Preliminary German comments following the Consultation Forum on space and water heaters

German Comments following the Ecodesign and Energy Label Consultation Forum on space and water heaters on 27th April 2023

- **4.)+5.):** Low/Medium temperature regimes:

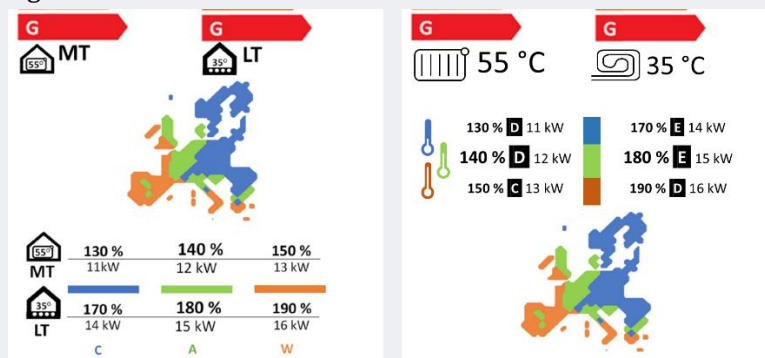
We acknowledge to express the relation to the insulation of the building, The abbreviations MT/LT will be hard to understand for consumers, and 35 °C might be misunderstood as an indoor temperature. We propose to indicate the LT/MT regime by using just an icon for a radiator or a floor heating loop and the dedicated feed temperature:

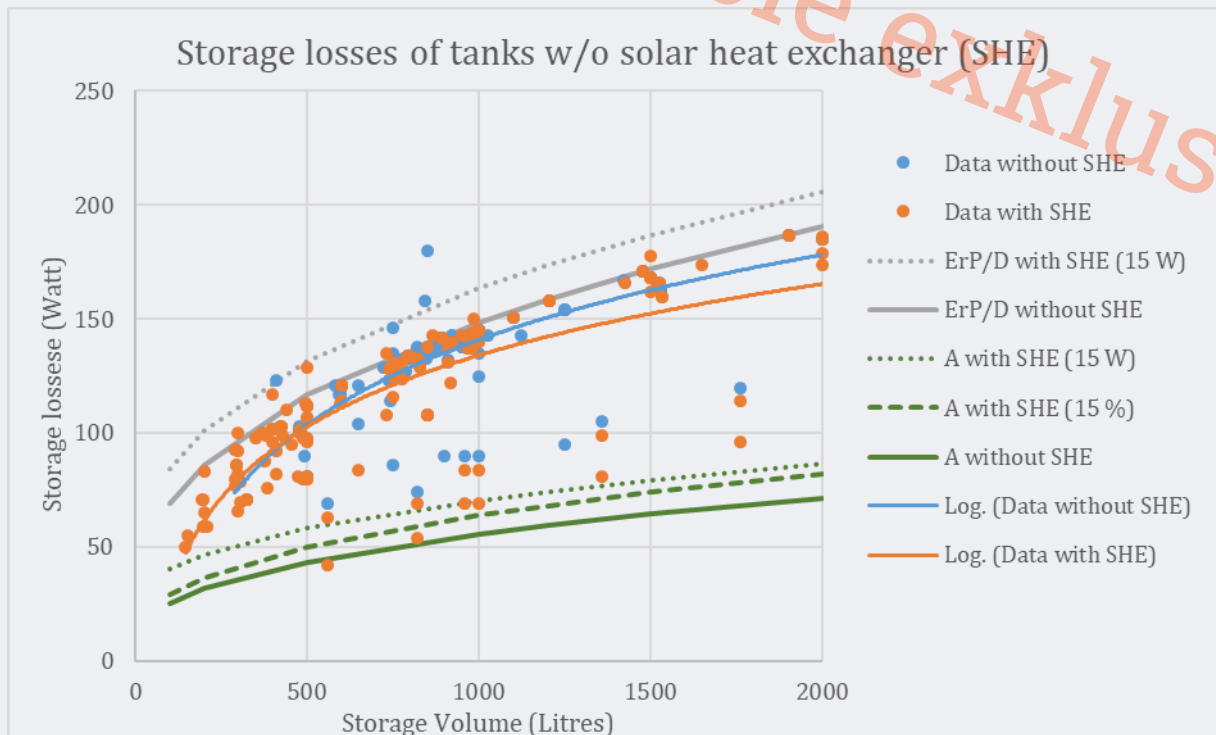
- We welcome the consideration of multivalent tanks that enable contribution of renewable energies. However, a fix bonus of 15 W is not appropriate as analysis of 2016 data shows: First, the trend lines (blue/orange) merge for smaller storages. Second, the bonus exceeds the class sizes for small volumes. Instead, a relative bonus of max. 15 % fits the product characteristics better (as indicated in the diagram for class A).

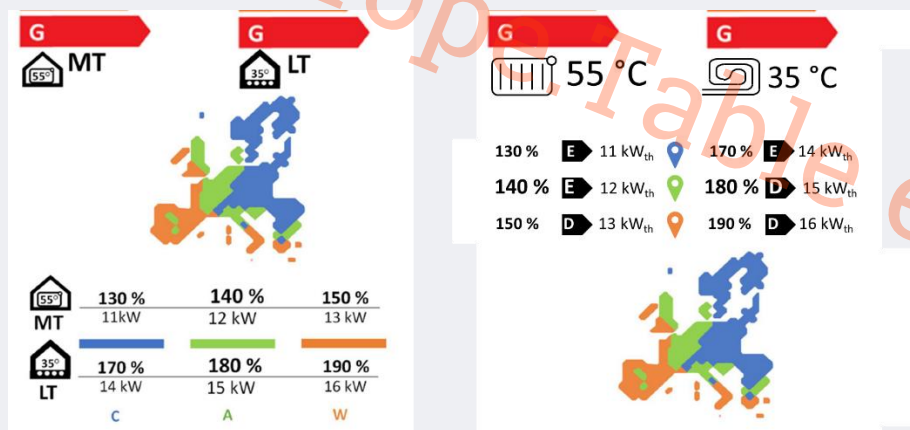
4.: The bottom table with additional data should be redesigned: use the same heating icons as **labels 1-3**, remove the abbreviations **c – a – w**, replace the colour bars by location indicators and add the efficiency classes in the three climates:
